Repair E9 error displayed on User interface Kite

DESCRIPTION:

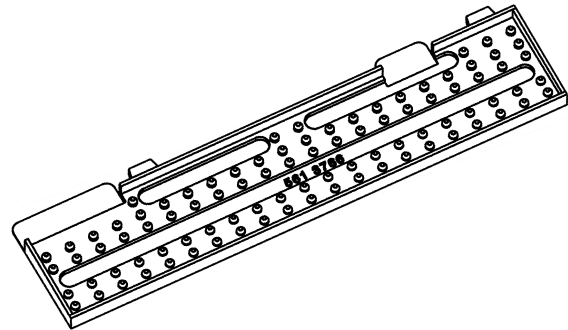
In Induction hobs, E9 error can be displayed on User Interface Kite. It is caused by old plastic carrier pressing on the solder joints of Kite C.

Current used plastic carrier

New silicone carrier

To repair E9 error displayed on User Interface Kite, it is required to exchange User Interface Kite C and additionally order silicone version of carrier according to table below.
